**BEFORE THE PUBLIC UTILITIES COMMISSION
OF THE STATE OF SOUTH DAKOTA**

**IN THE MATTER OF THE
APPLICATION BY DAKOTA RANGE
I, LLC AND DAKOTA RANGE II, LLC
FOR A PERMIT OF A WIND ENERGY
FACILITY IN GRANT COUNTY AND
CODINGTON COUNTY, SOUTH
DAKOTA, FOR THE DAKOTA RANGE
WIND PROJECT**

* **DAKOTA RANGE I, LLC AND DAKOTA
RANGE II, LLC RESPONSES TO
STAFF'S FIRST SET OF DATA
REQUESTS TO APPLICANT**

EL18-003
*
*
*
*
*
*
*

- Project Boundary
- Parcel Boundary
- Primary Turbine
- Spare Turbine
- 500 ft. Radius
- Buildable Area (V136 at 82m)

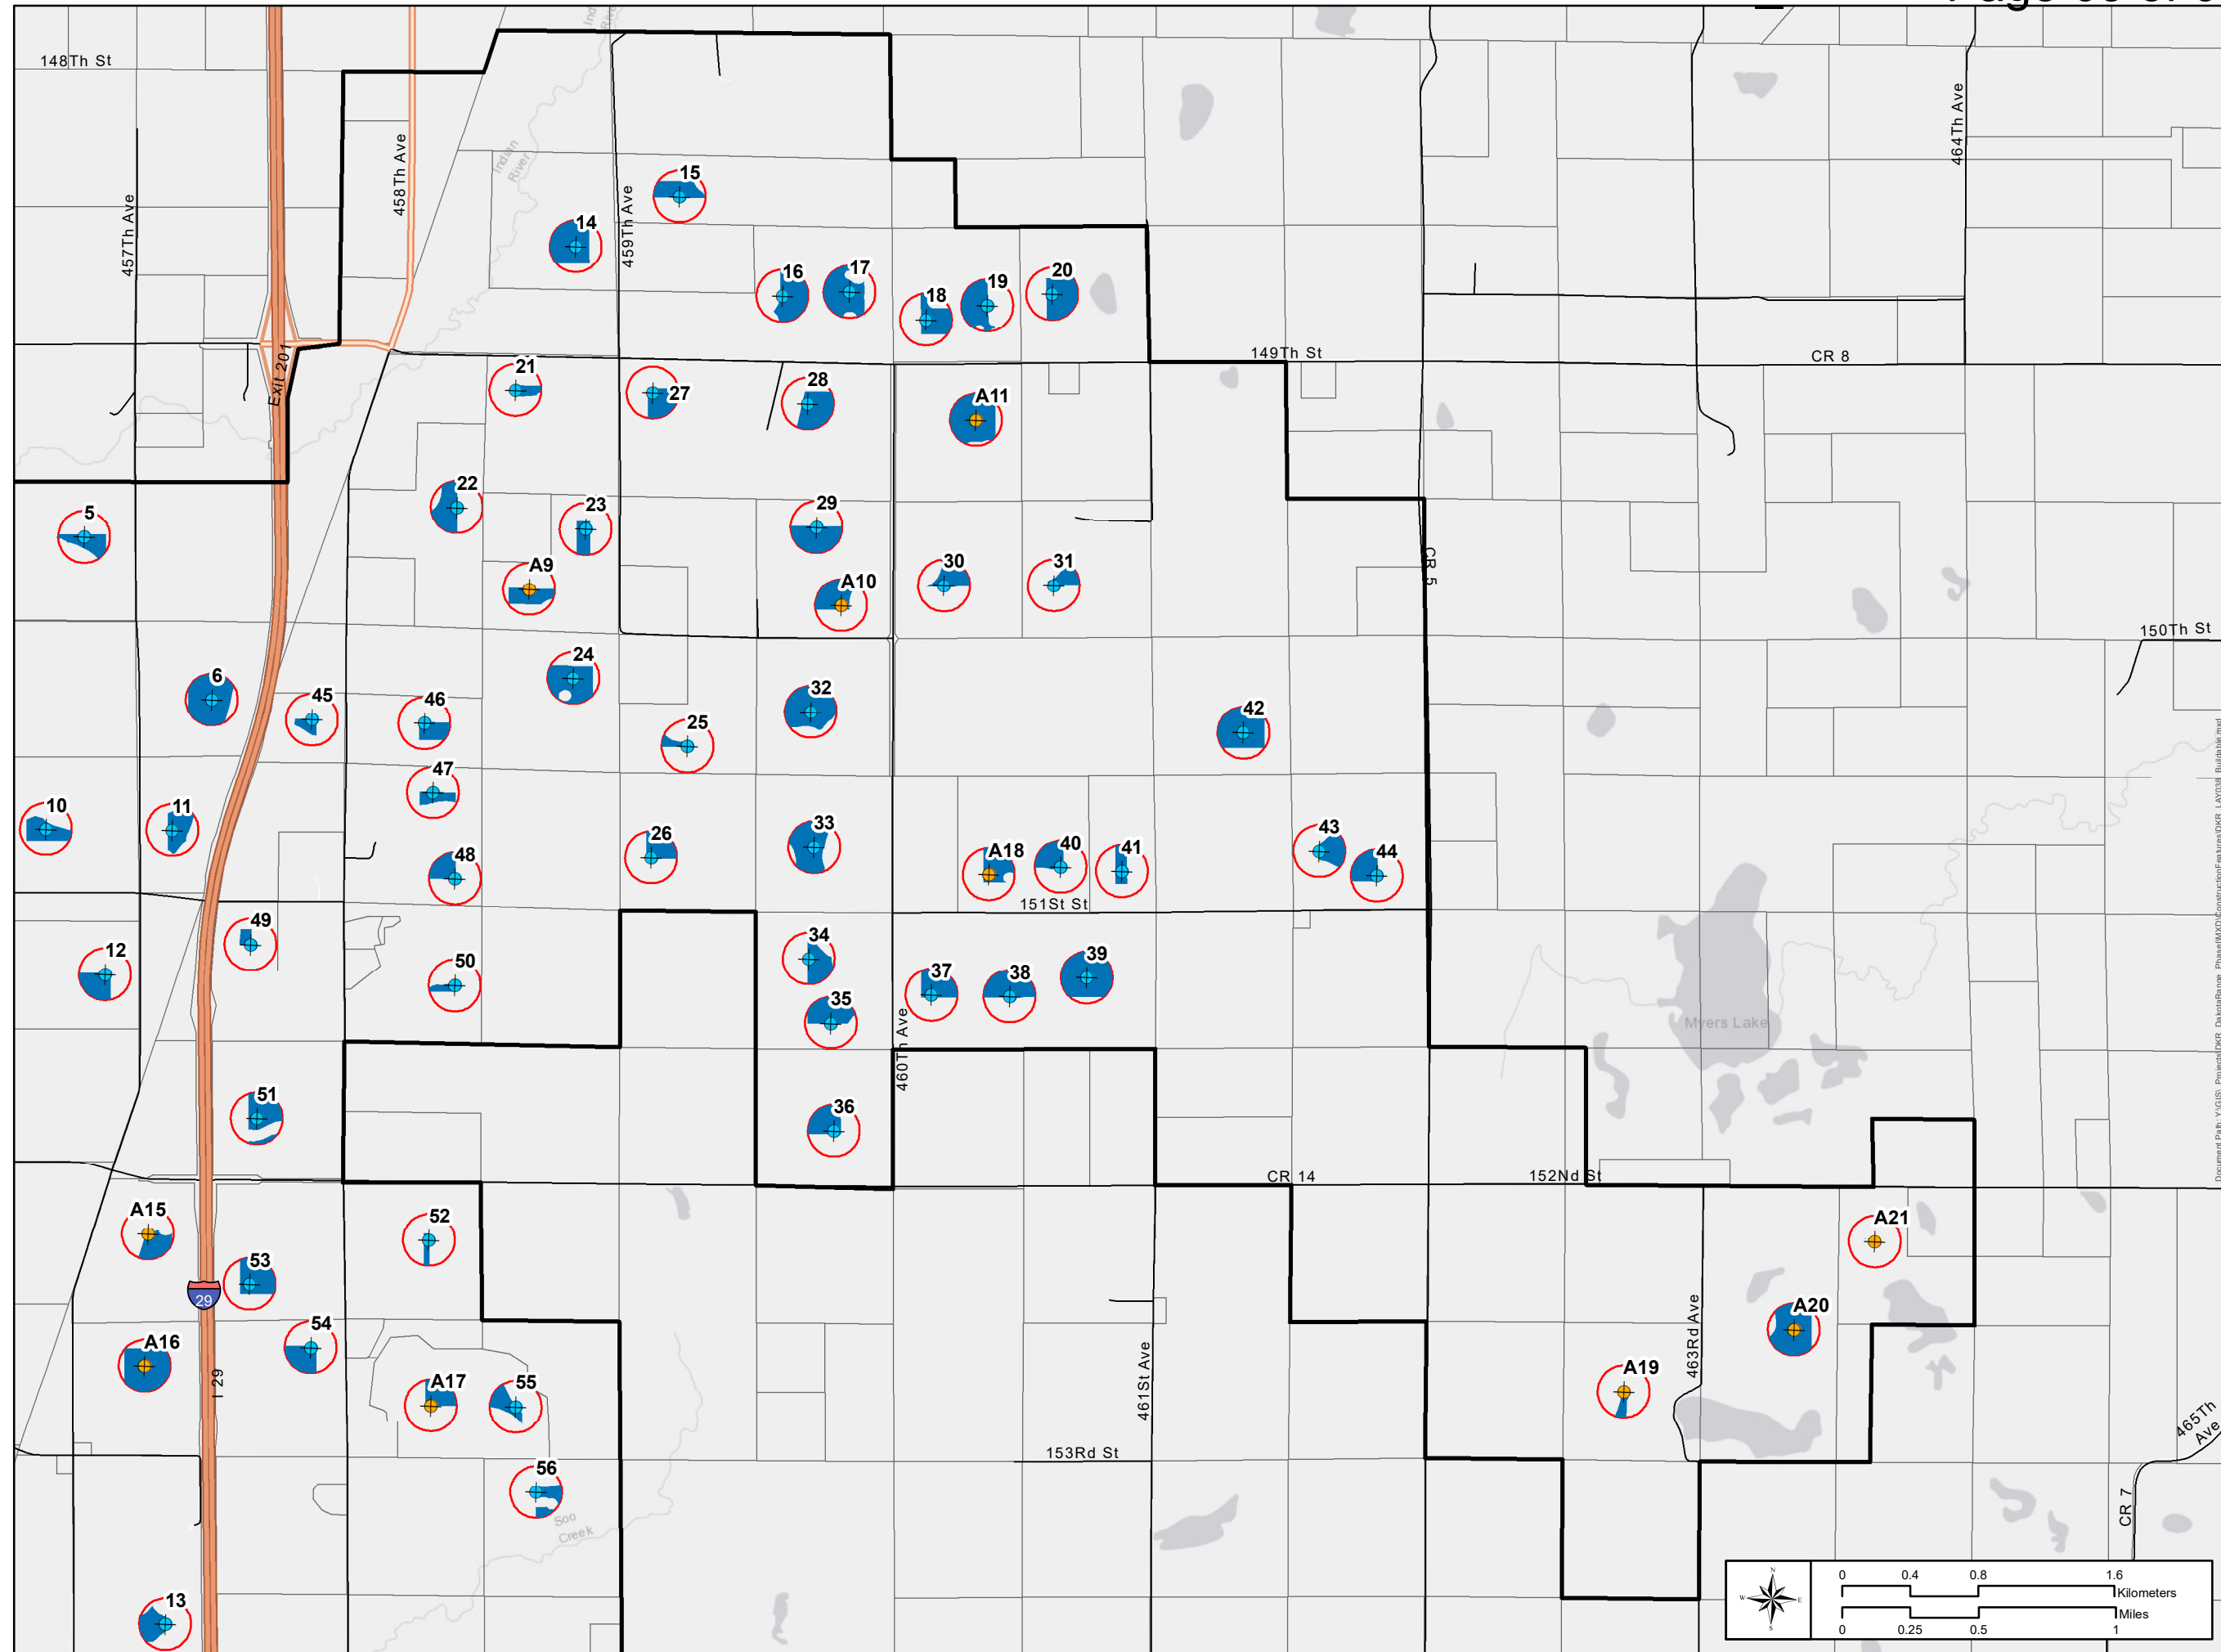
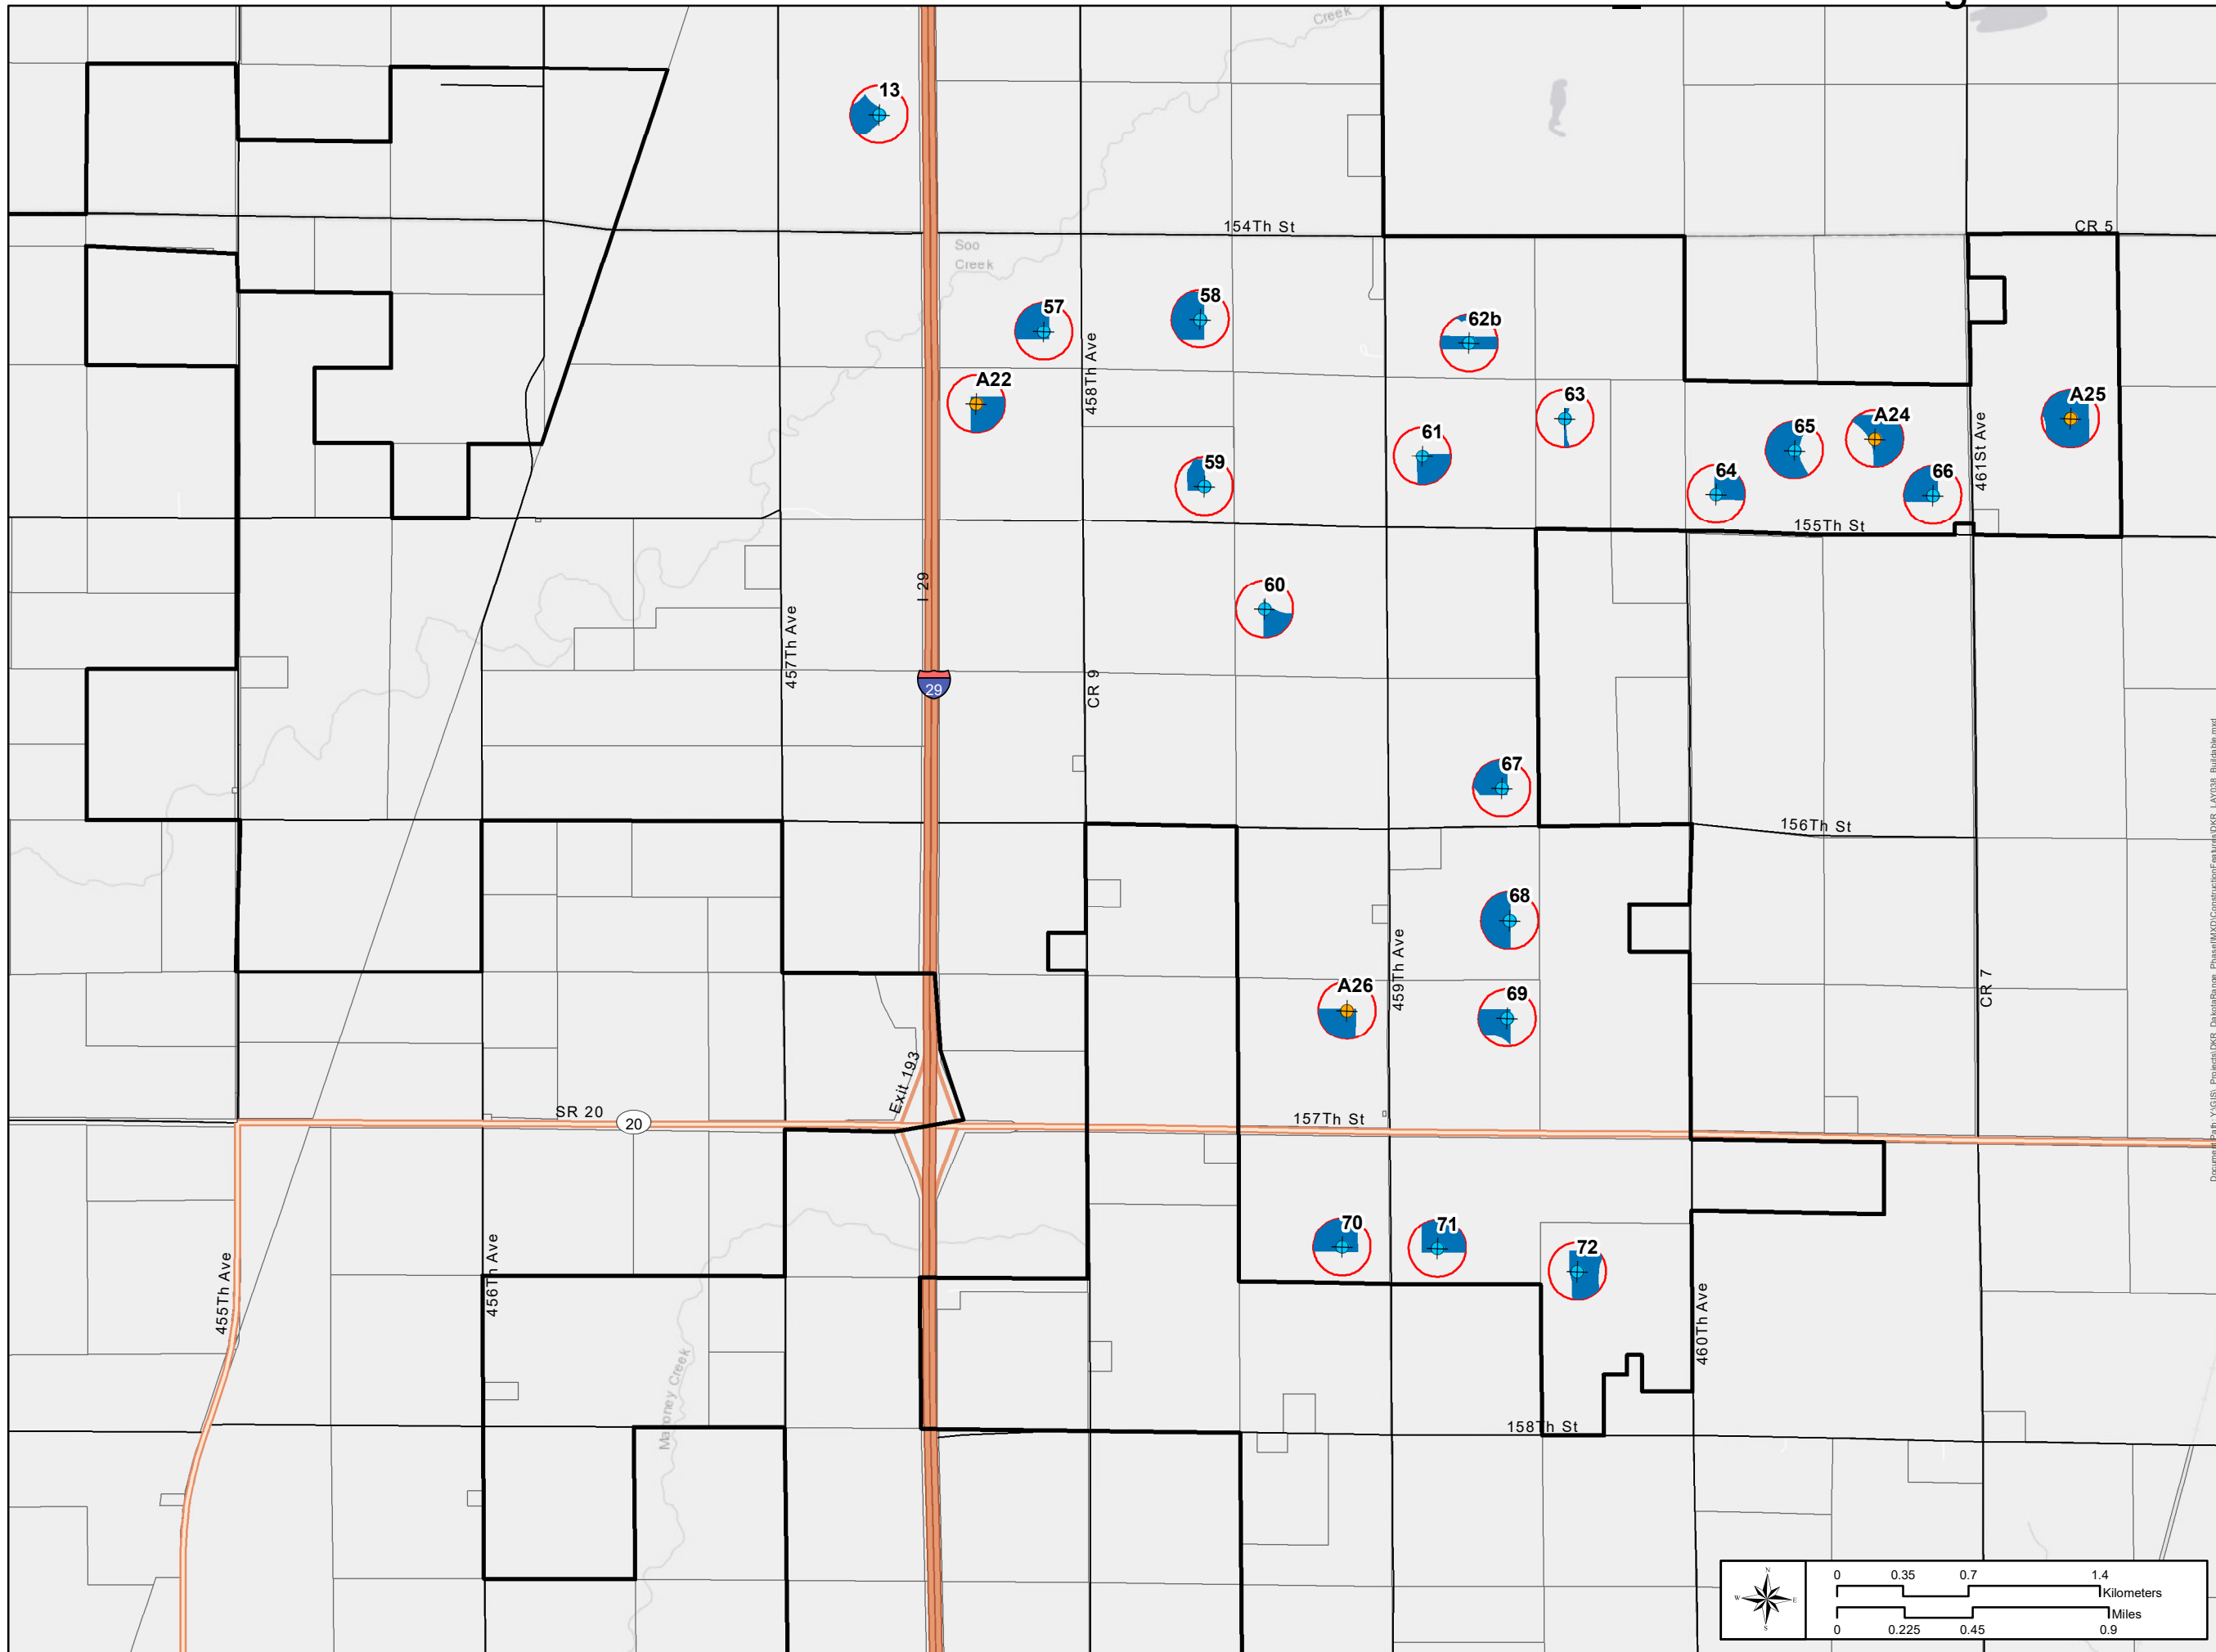
- 7-3) Please refer to the Constraints Map depicted on Figure 5:**

Brenna Gunderson: Turbines 16, 18, 19, and 20 are shown in a non-Buildable Area as a result of an error in creating Figure 5 in which an outdated version of the Buildable Area was inadvertently used.

- c) **Please resubmit Figure 5 to also show the turbine flexibility requested, and submit Figure 5 with more detail (ie – broken out into 4 or 6 sub-regions of the project).**

Brenna Gunderson: See the attached revised Figure 5 maps.
